**DC-10**

**SERVICE BULLETIN**

Bulletin 35-16  
DC-10 SC 1981/2134

OXYGEN - Passenger - Modify Oxygen Compartment In Passenger Seat Back And Compartment Partition.

FIGURE 1 (SHEET 1 OF 8)

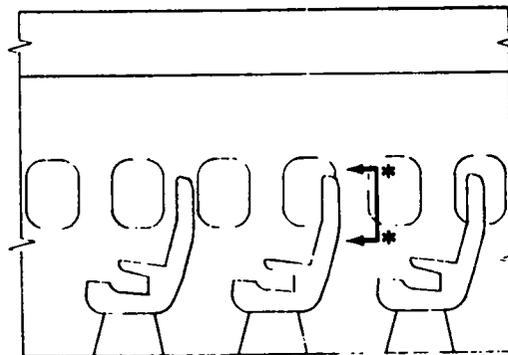
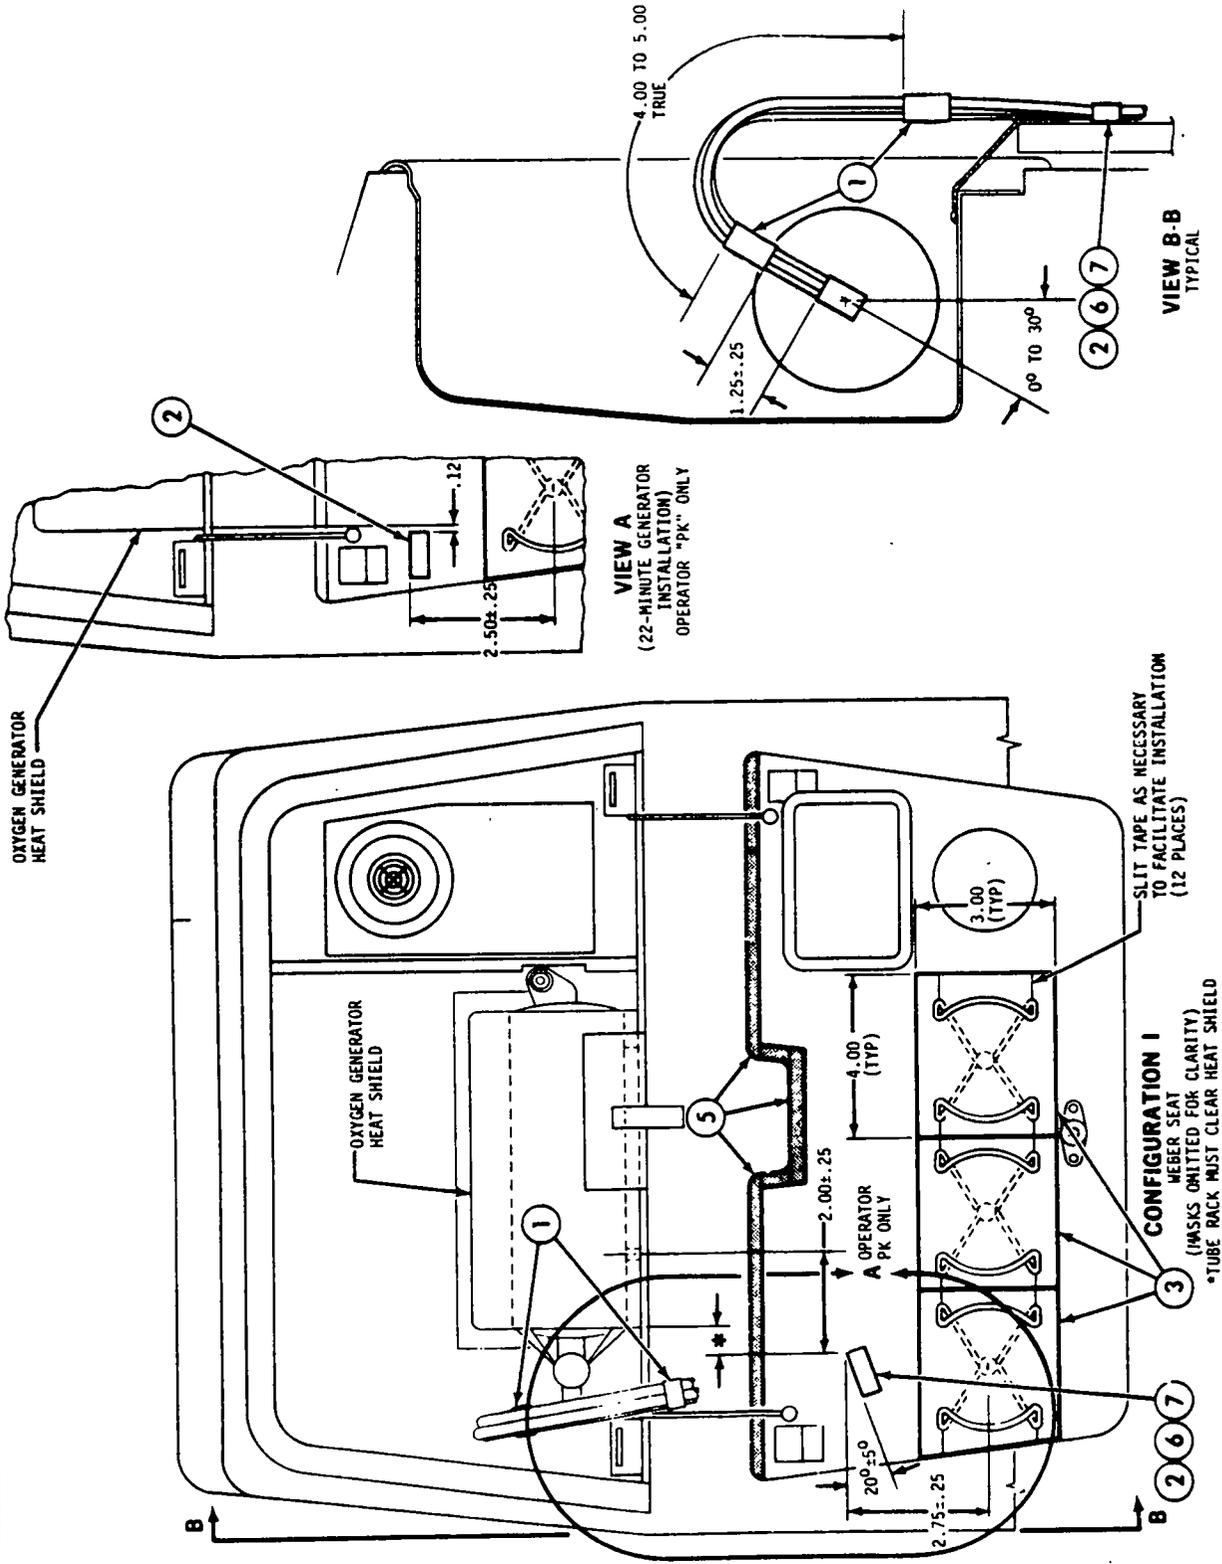
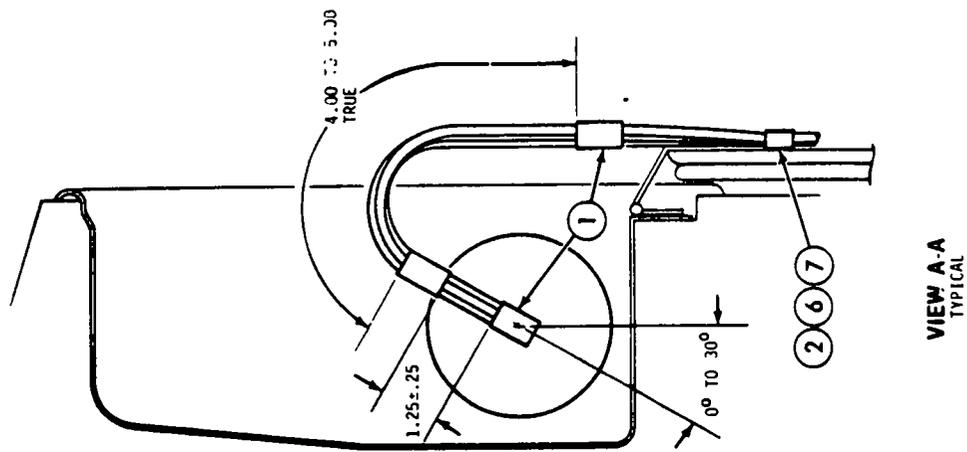
- ① APPLY TWO OR THREE COMPLETE WRAPS OF P-2650 TAPE AROUND OXYGEN HOSES TO DIMENSIONS SHOWN.

- ② BOND NMC700-3 TUBE RACK TO DOOR, TO DIMENSIONS SHOWN, USING EA9311 A/B ADHESIVE. (SEE DOUGLAS PROCESS STANDARD (DPS) 1.07-66, TYPE 6.)
- ③ INSTALL 425 TAPE ON OXYGEN MASK HOLDER AS SHOWN. (SEE DPS 1.091.)
- ④ CONFIGURATION IV - FILL GAP BETWEEN OXYGEN MASK HOLDER AND RAISED SURFACE OF DOOR WITH SILASTIC 140 SILICONE ADHESIVE. (SEE DPS 1.07-2, TYPE 7.)
- ⑤ INSTALL P133UA TAPE ON DOOR AS SHOWN. CUT TAPE AS REQUIRED FOR PROPER FIT. (SEE DPS 1.091.)

- ⑥ REMOVE 4282 TAPE FROM NMC700-3 TUBE RACK AND COMPARTMENT DOOR.
- ⑦ BOND NMC700-3 TUBE RACK TO COMPARTMENT DOOR, TO DIMENSIONS SHOWN, USING EA9311 A/B ADHESIVE. (SEE DPS 1.07-66, TYPE 6.)

FIGURE 1 (SHEET 3 OF 8)

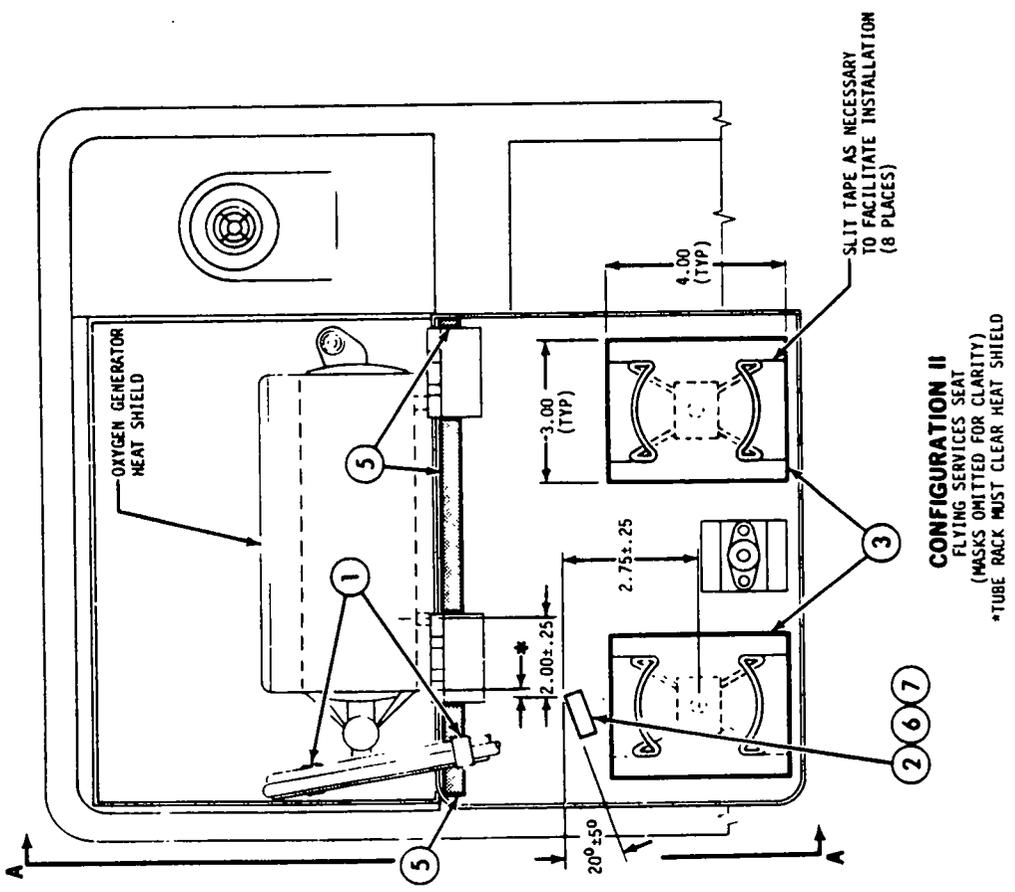
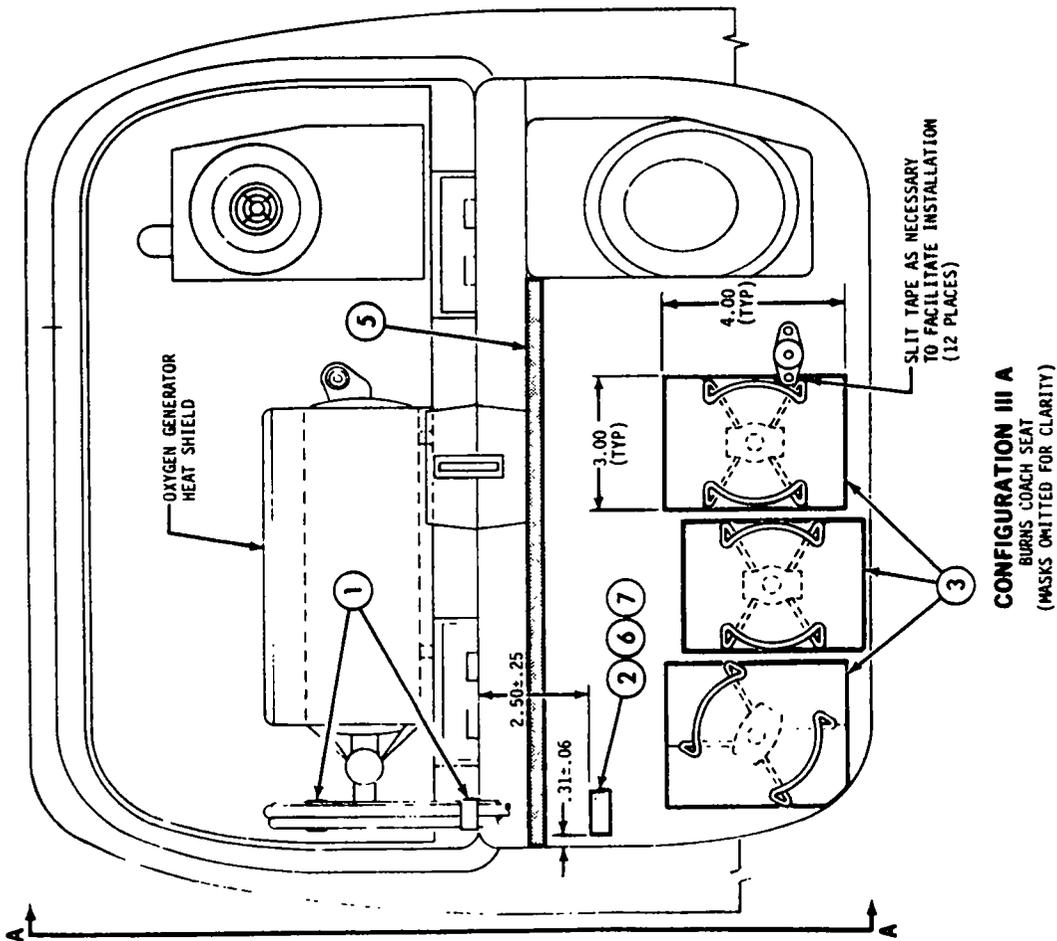
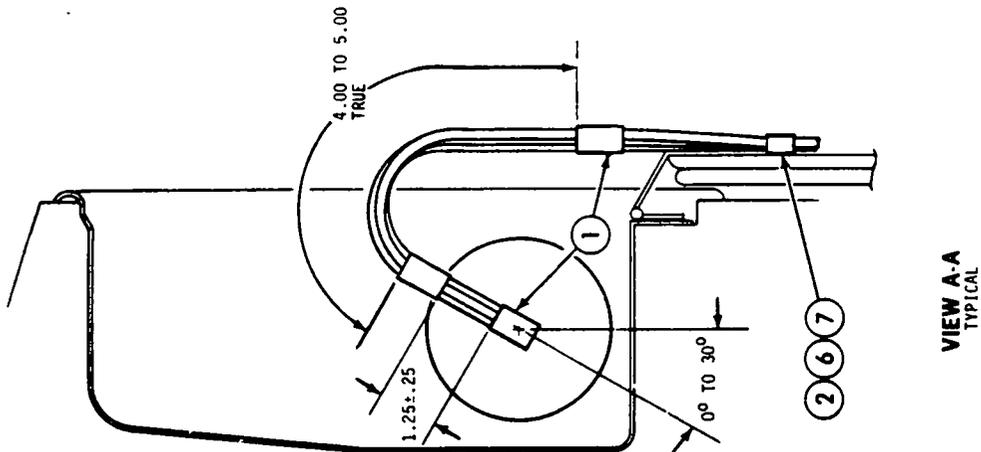
CONFIGURATION II  
FLYING SERVICES SEAT  
(MASKS OMITTED FOR CLARITY)  
\*TUBE RACK MUST CLEAR HEAT SHIELD

FIGURE 1 (SHEET 5 OF 8)

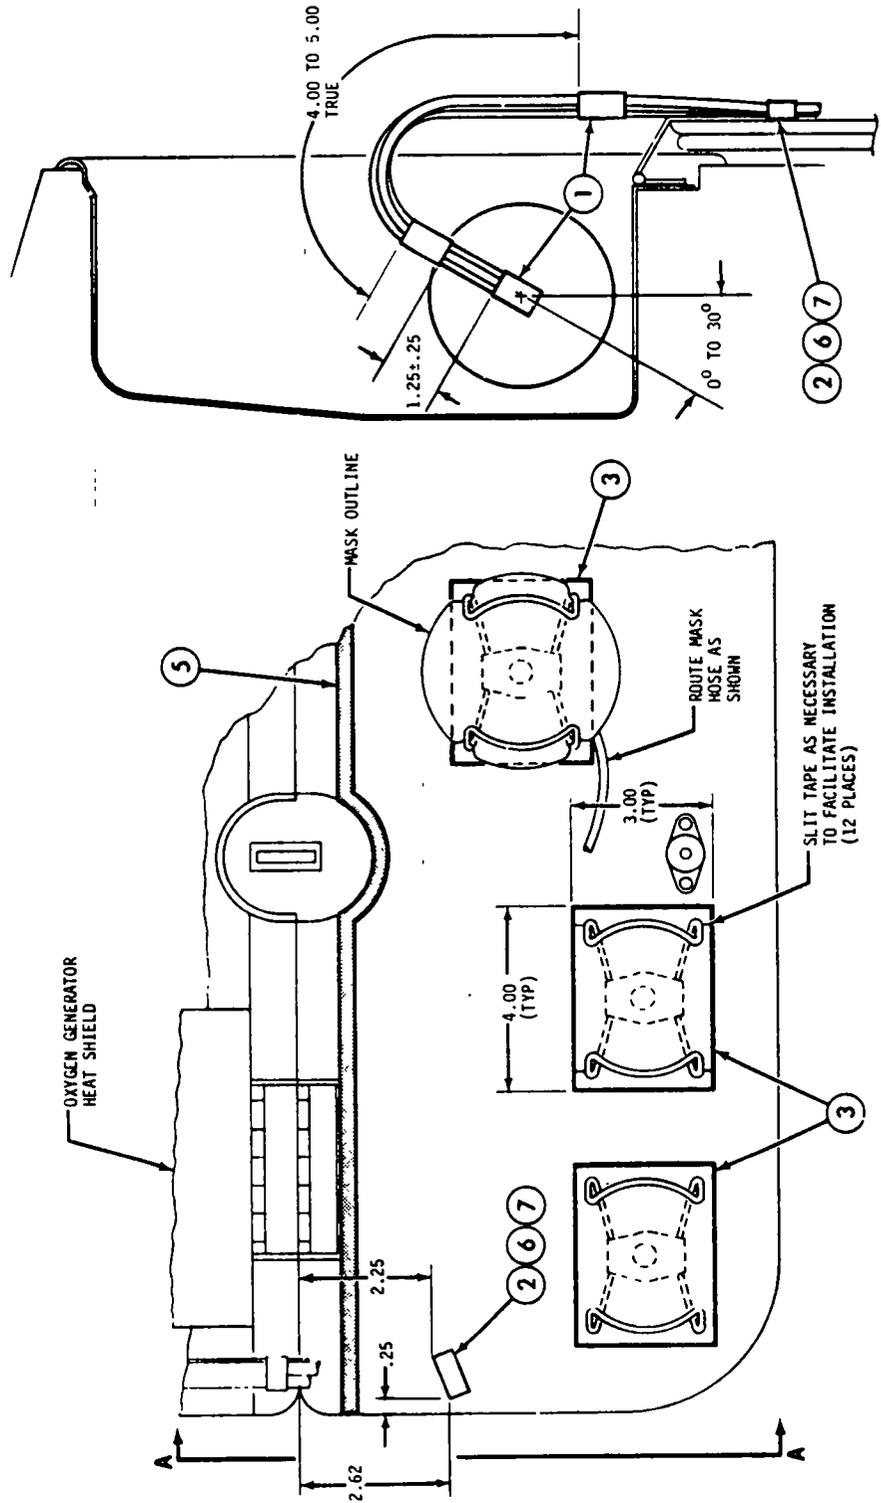
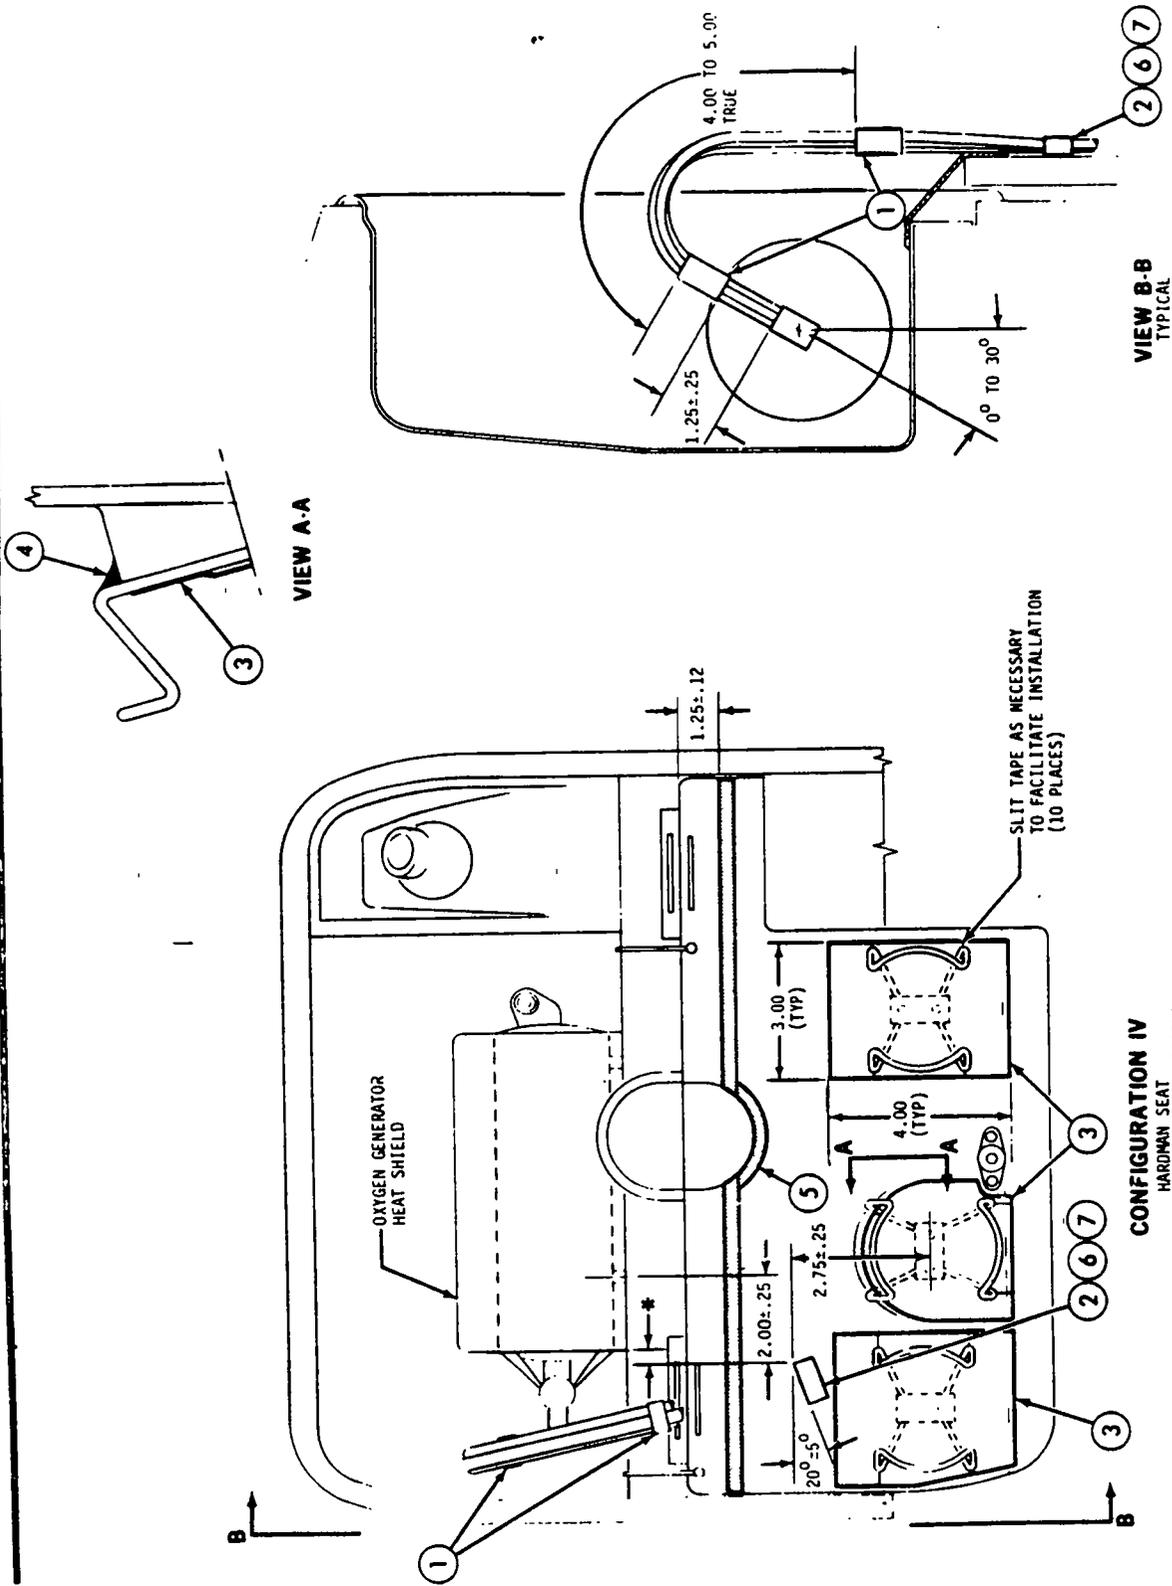
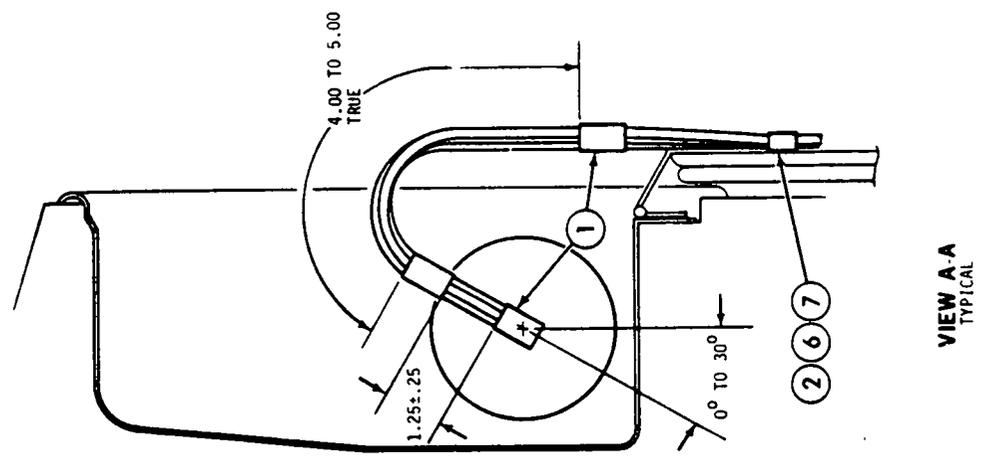
**CONFIGURATION III B**  
BURNS FIRST CLASS SEAT  
(2 MASKS OMITTED FOR CLARITY)

FIGURE 1 (SHEET 7 OF 8)

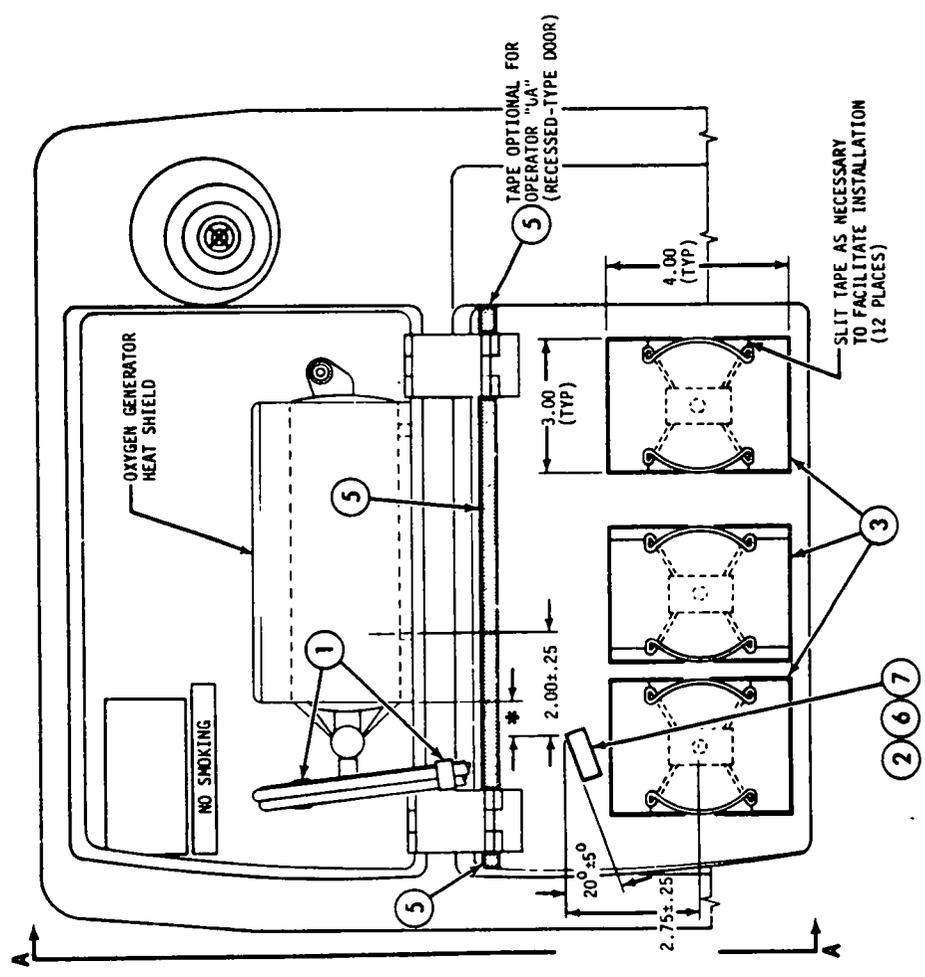
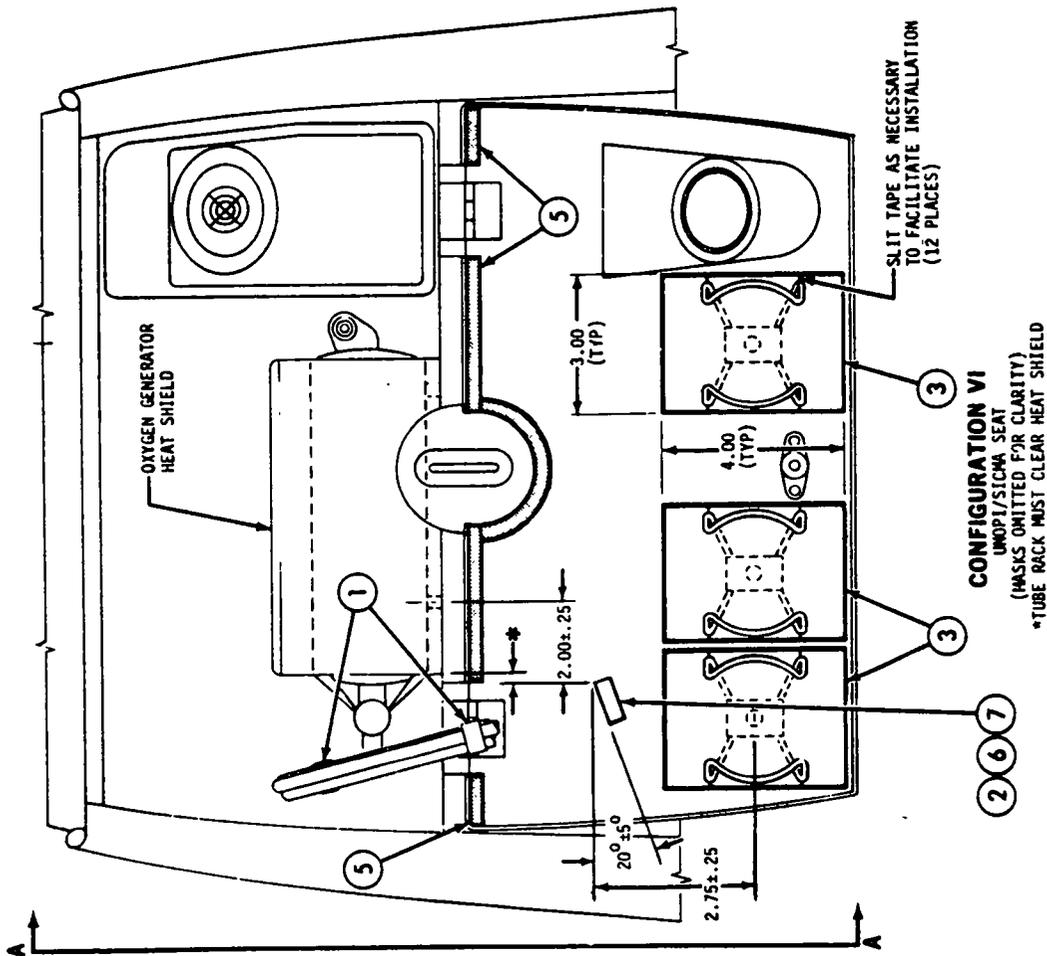
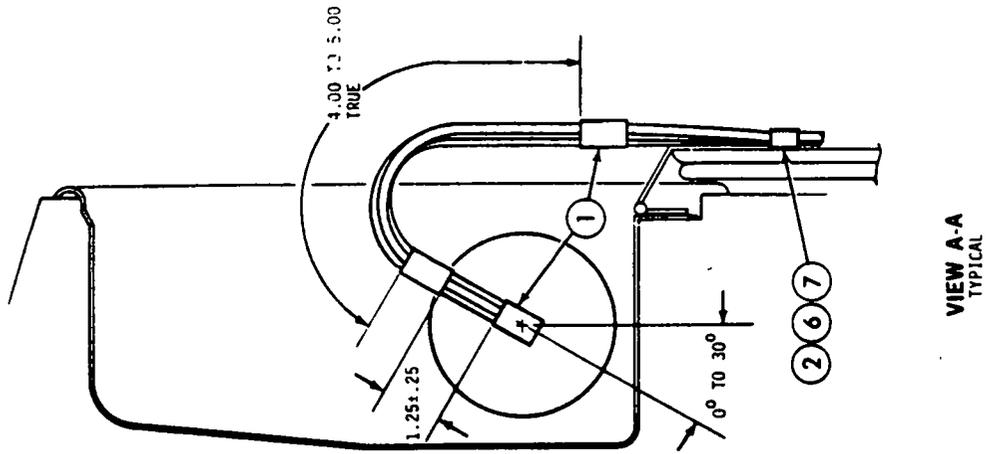
**CONFIGURATION V**  
UNIVERSAL OIL PRODUCTS SEAT  
(MASKS OMITTED FOR CLARITY)  
\*TUBE RACK MUST CLEAR HEAT SHIELD
